RESPONSE TO REQUEST FOR ADDITIONAL INFORMATION – DA 240159

Premise have prepared this letter on behalf of ACEnergy Pty Ltd to respond to a request for additional information (RFI) issued by Yass Valley Council (YVC) via the NSW planning portal on 25 October 2024. The request is made in respect of development application (DA) 240159 and relates to the proposed development of Murrumbateman Distribution Battery Energy Storage System (D-BESS) at 3 Turton Place, Murrumbateman.

DRAWING NR:	G-1.2_023118		
DRAWN BY:	XZ	APPROVED BY:	AJ
PROJECT MGR:	LZ	ISSUE DATE:	20/11/2024
SCALE:	AS INDICATED	ISSUE:	FOR APPROVAL
SHEET SIZE:	A3	PROJECT NO.:	23118
REV. NO.:	B

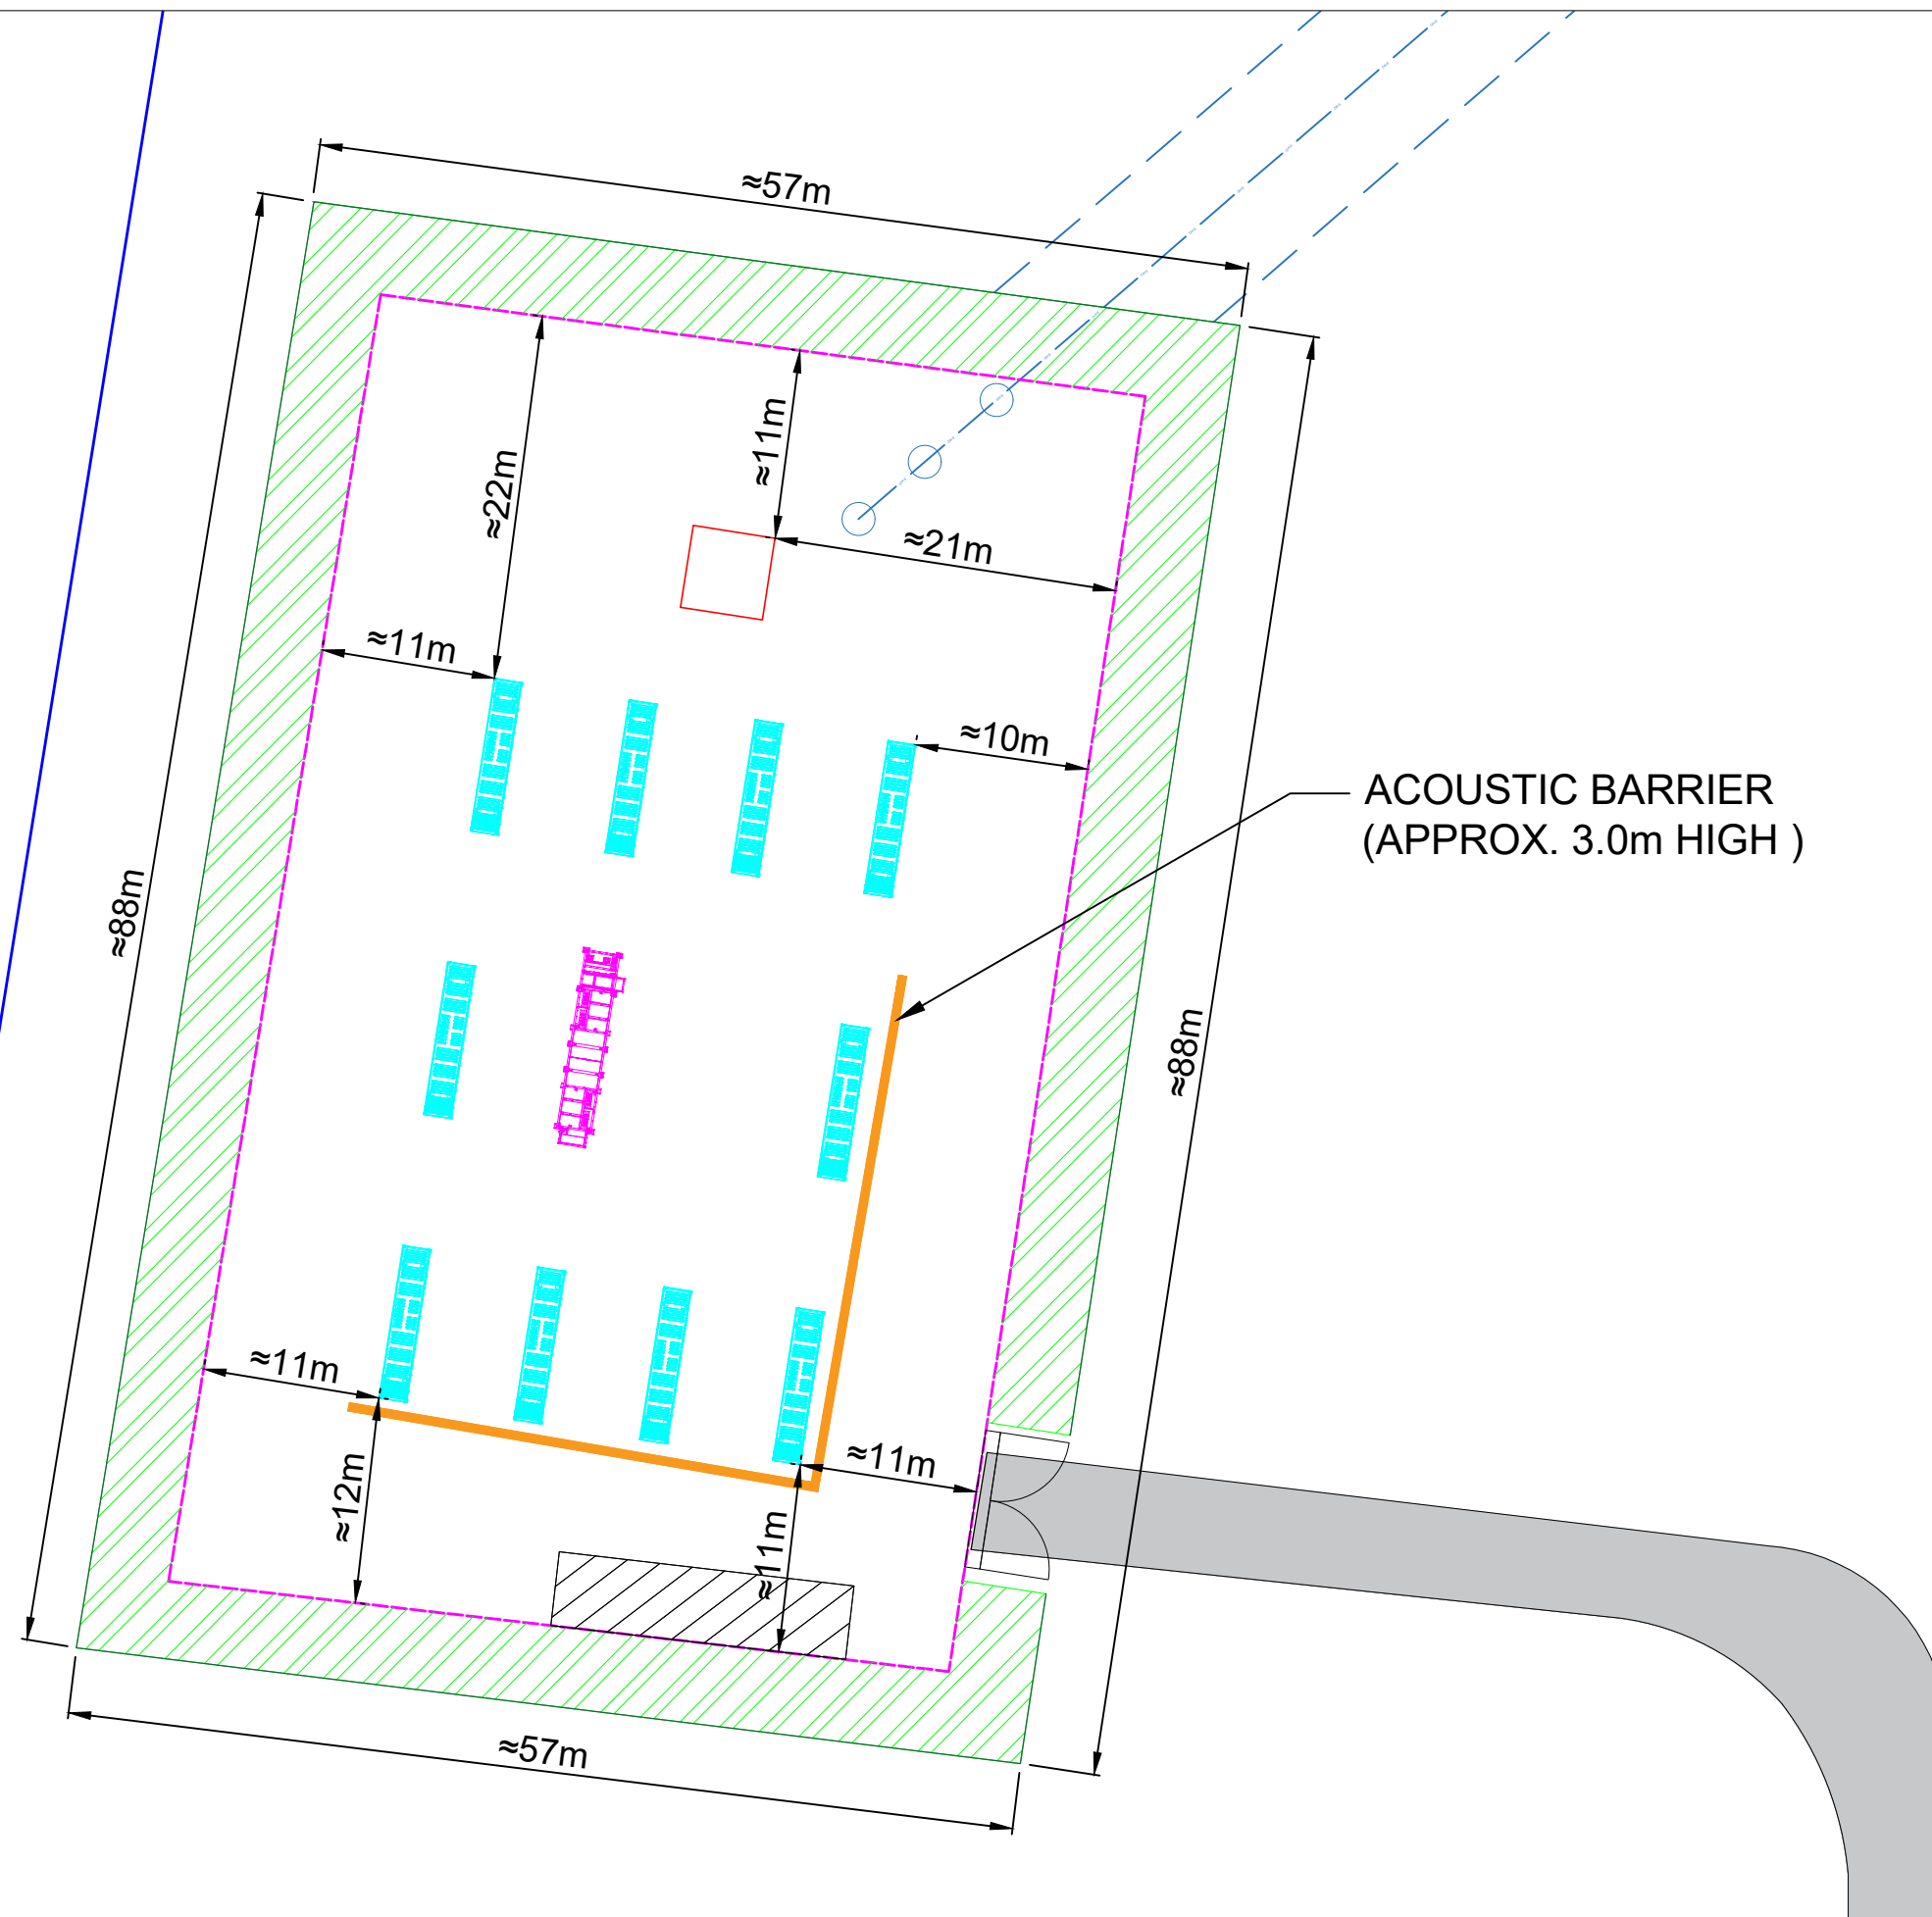
<p>2.</p>	<p>Acoustic barriers</p> <p><i>The acoustic report prepared by Watson Moss Growcott dated 6 May 2024 details recommendations for the installation of an acoustic barrier to achieve acceptable noise levels. This is shown on Site Plan 1 of 2 (drawing G-1.1._023118), however not on all other relevant drawings and documents. The following information is required:</i></p> <p>The revised acoustic report provides an indication on the general specifications for the proposed acoustic barrier. To achieve the noise reduction qualities the AR details that the barrier must be designed and constructed to achieve:</p> <ul style="list-style-type: none"> • A minimum height of 3000 mm to address predicted noise levels and the results of the noise model. • A surface minimum weight of 12 kg/m²/ • No gaps between the panels and between the panel and ground

Additional Information Requested	Comments
<ul style="list-style-type: none"> • <i>Separate, dimensioned, elevation drawings of the acoustic barrier, including details of construction type, material, and colours/finishes.</i> • <i>Security Fence & Landscape Elevation (drawing G-5.0_023118) is to be revised to also show acoustic barrier.</i> • <i>Landscape plans prepared by Ground Control Landscape Architects to be revised to show acoustic barrier.</i> 	<ul style="list-style-type: none"> • Lining on the electrical infrastructure side of the barrier that implements 100 mm of thick absorbing materials which achieve a Noise Reduction Coefficient (NRC) of not less than 0.9. <p>As noted above, the final specification of selected electrical equipment and determination if acoustic wall is deemed required or not will be finalised after completion of project detailed design. The final dimensions, elevations of noise wall including finishing materials and colour can be provided to Council once project detailed design is completed.</p> <p>The applicant has no objection to a condition of consent requiring the provision of this information to Council's satisfaction prior to issue of a construction certificate.</p> <p>Notwithstanding this, the revised DA Drawings including the Security Fence & Landscape Elevation (Refer to Appendix A of revised SEE) together with the revised Landscape Plan (Refer to Appendix F of revised SEE) have been amended to provide an indication of the proposed acoustic barrier.</p>

ACOUSTIC BARRIER
(APPROX. 3.0m HIGH)

SECURITY FENCE AND TWO ROWS OF LANDSCAPE SIDE VIEW

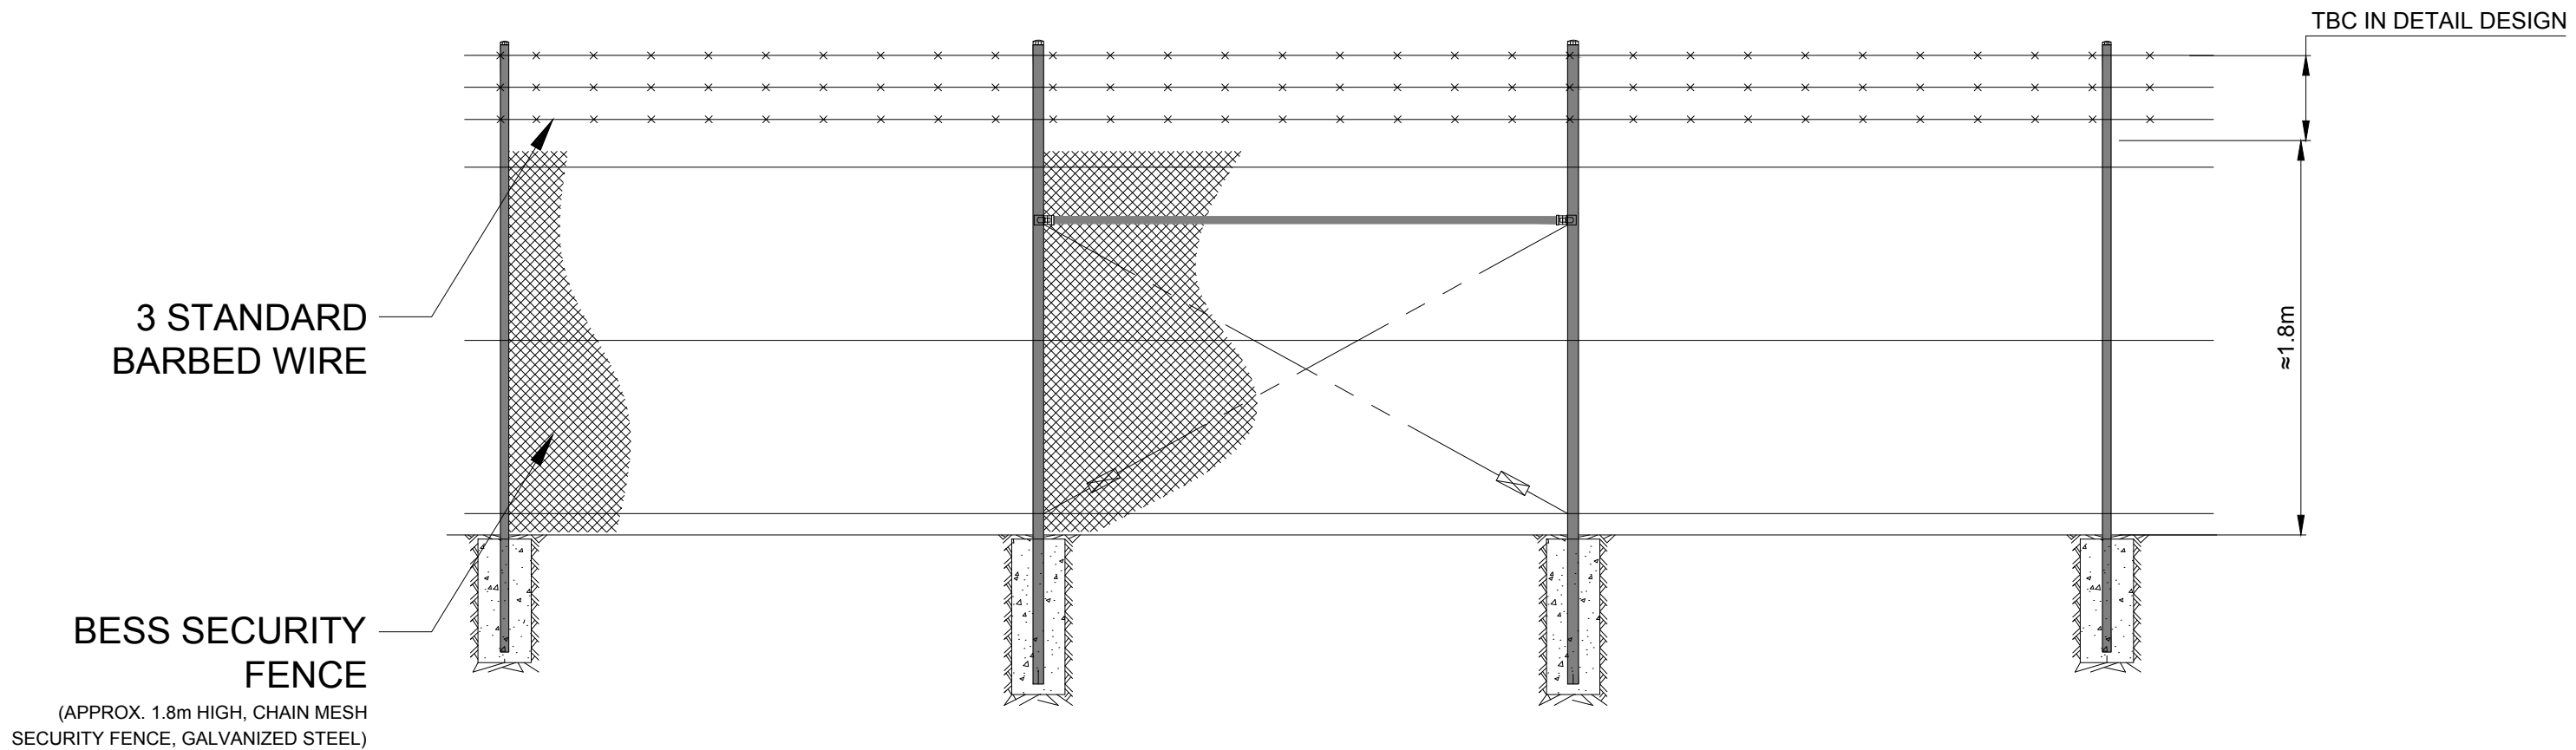
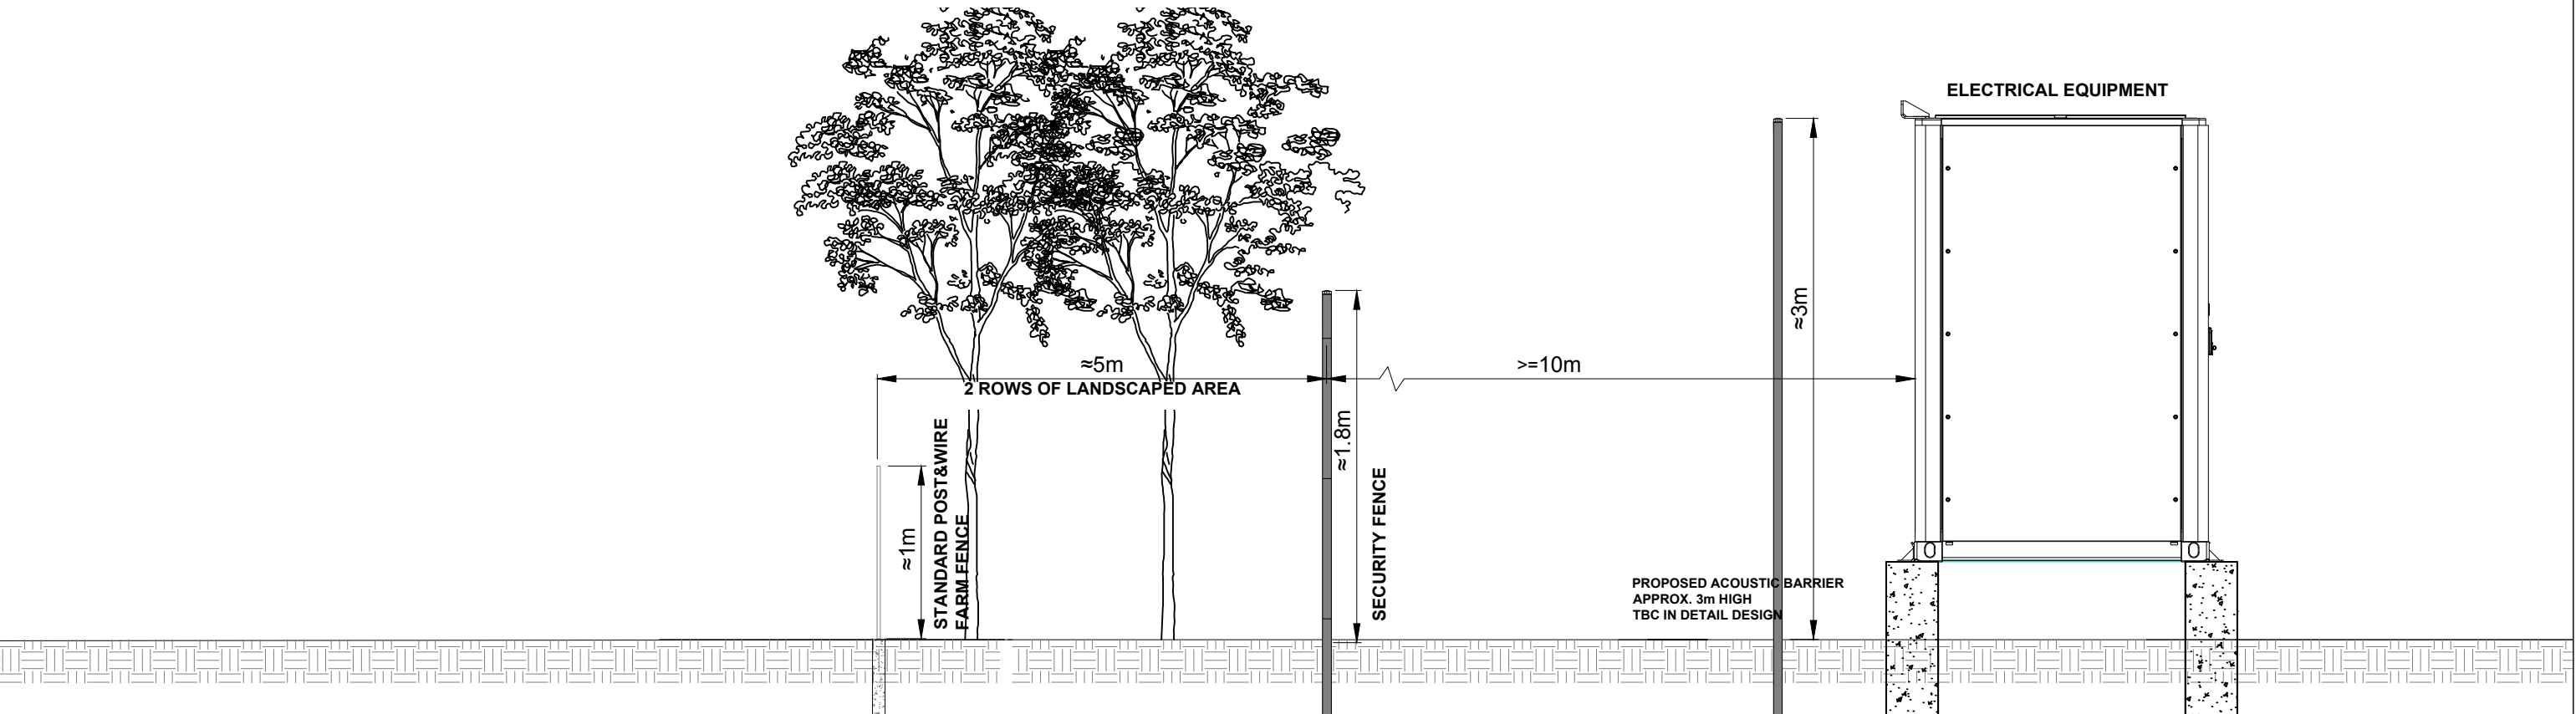
<p>4.</p>	<p>Landscaping <i>All plans are to show the two rows of landscaping as proposed, noting that some plans are incorrectly only showing one row.</i></p>
<p>5.</p>	<p>Yass Valley Development Control Plan 2024 <i>The Yass Valley Development Control Plan (YV DCP) 2024 came into effect on 1 August 2024, and had been adopted by Council in draft form for public exhibition at time of Development Application</i></p>
